CITY OF ALBUQUERQUE

RE: Transport Housing Apartments 2900 Transport St. SE Conceptual Grading & Drainage Plan Engineer's Stamp Date: 05/20/21 Hydrology File: M15D023H

Based upon the information provided in your submittal received 05/21/2021, the Conceptual Grading & Drainage Plan **is not** approved for action by the DRB on Preliminary Plat or Site Plan for Building Permit. The following comments need to be addressed for approval of the above referenced project:

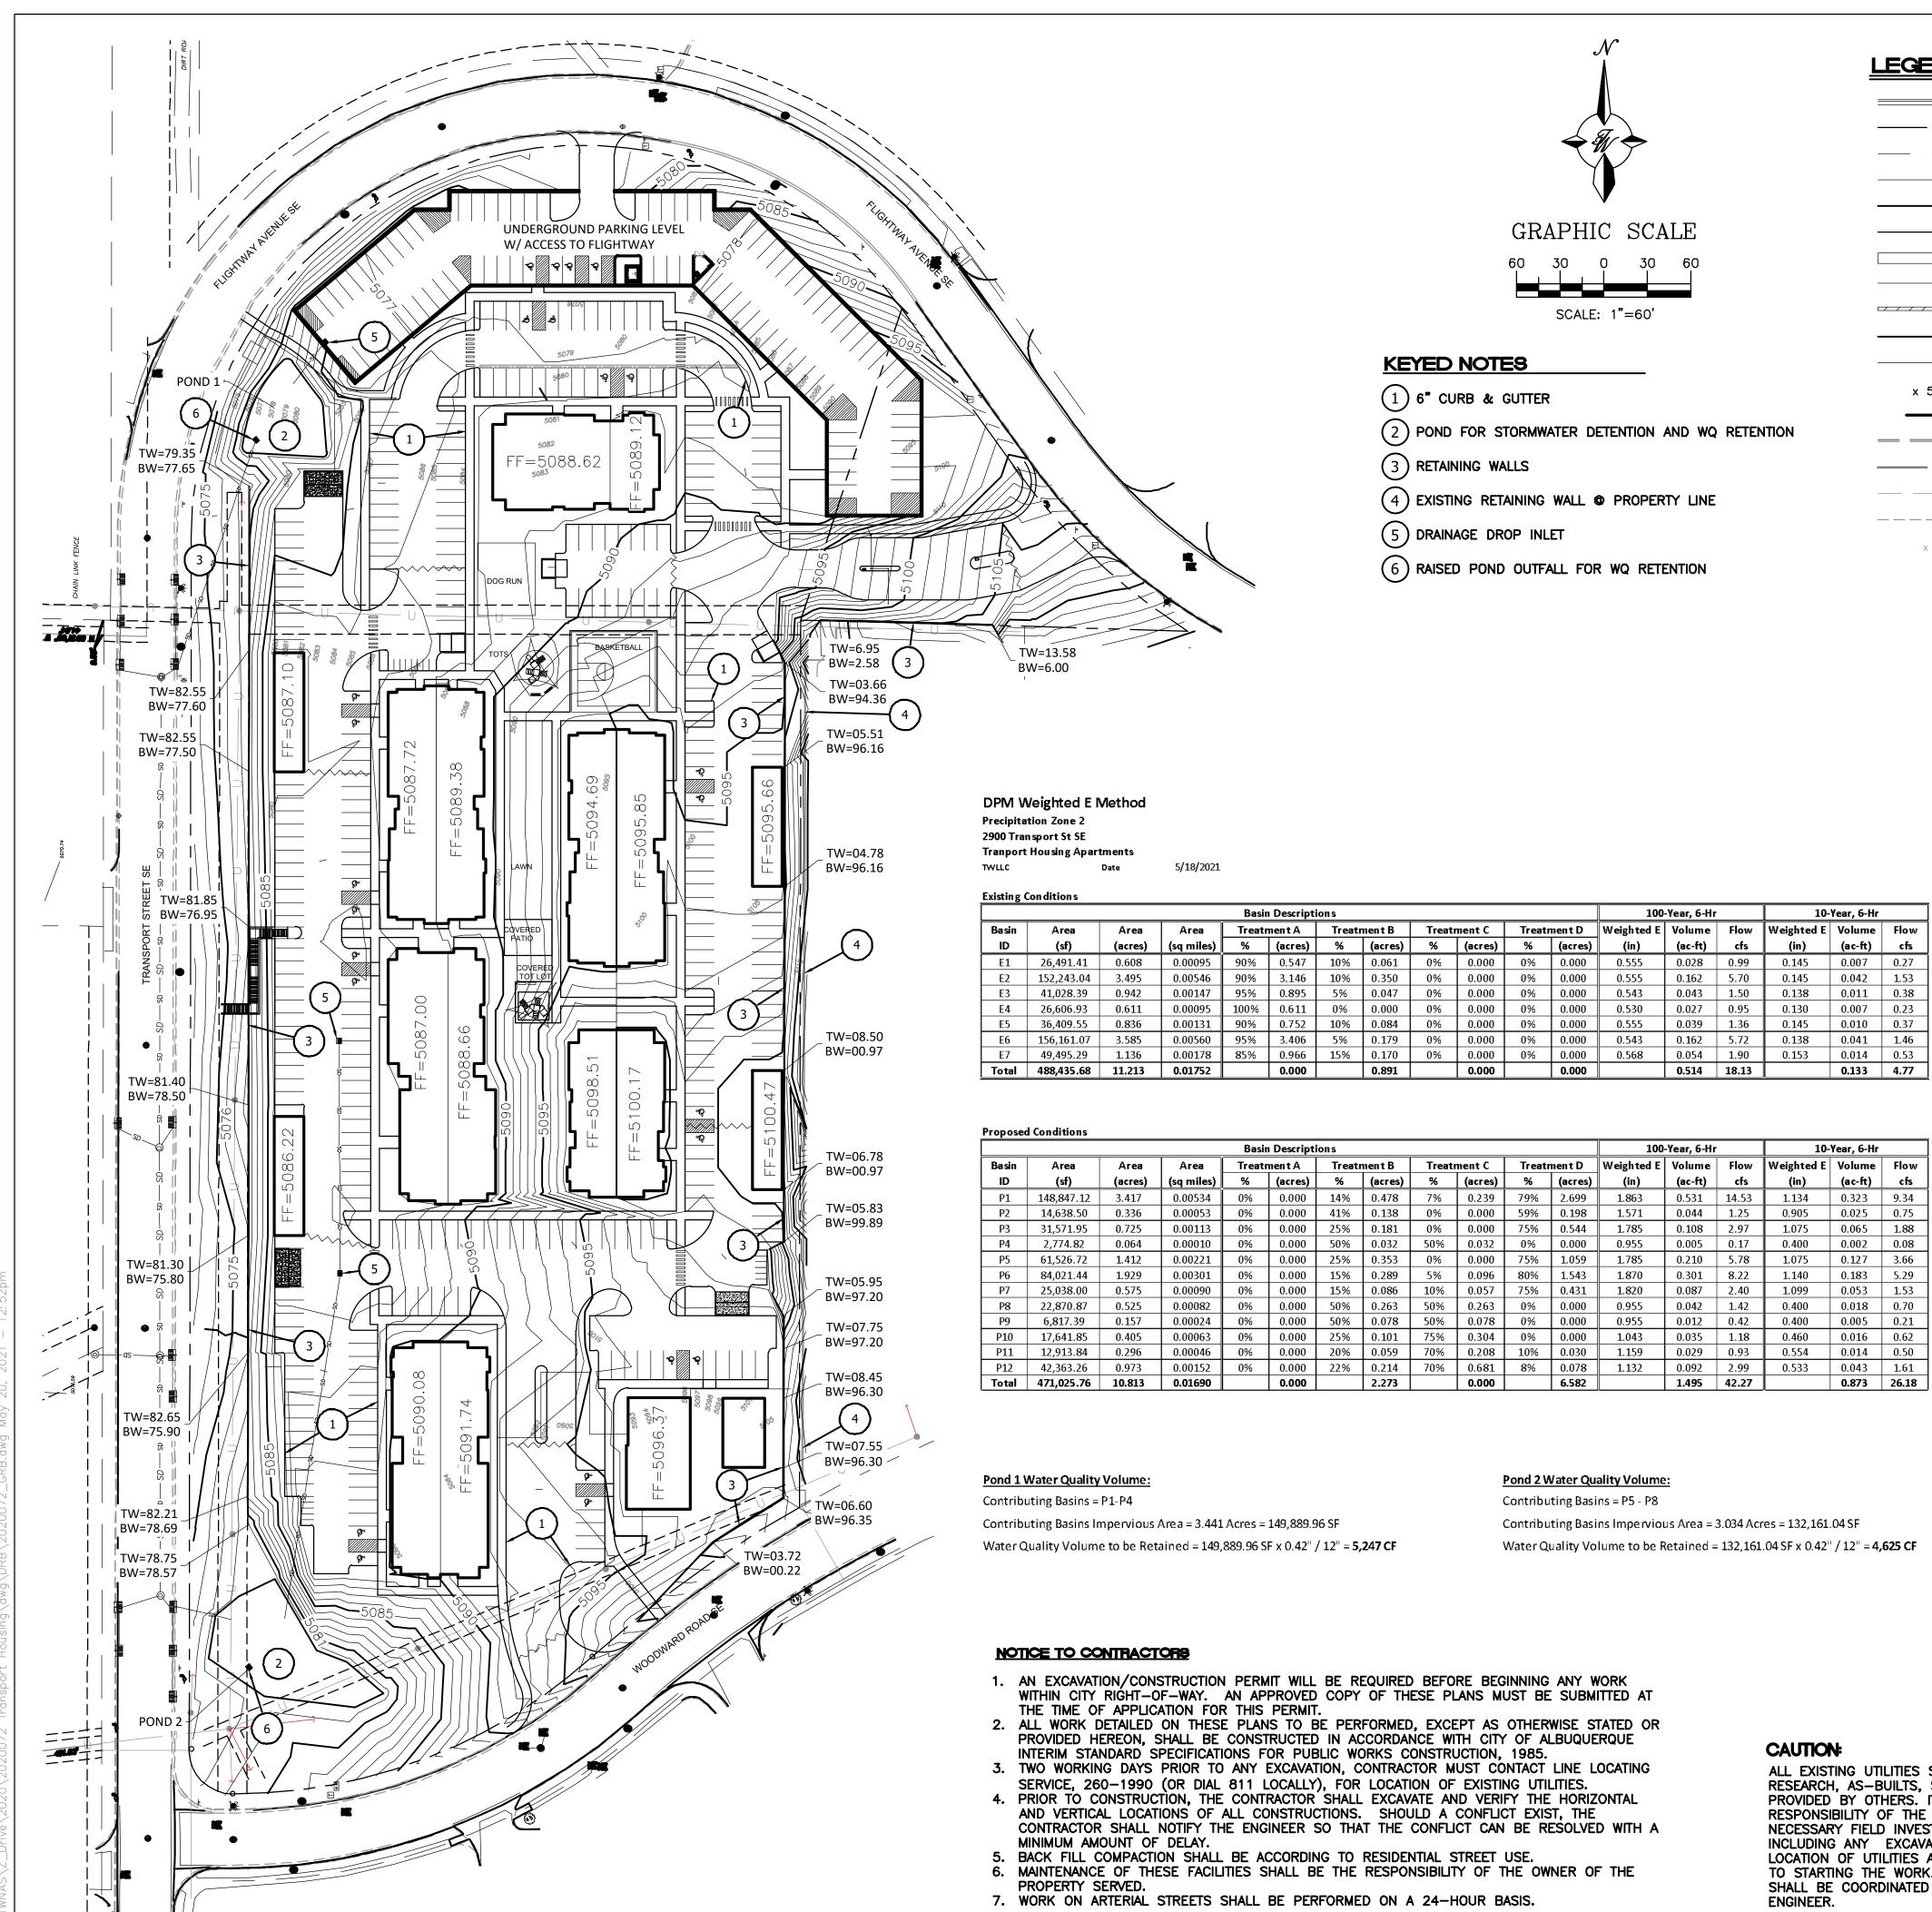
- 4. Sheet 2.2. Please add some drainage arrows on the proposed drainage basins showing how each area will drain to the respected detention pond.
- 5. Sheet 2.1 Please show maintenance ramps for each detention ponds. Also show a driveway for each pond.
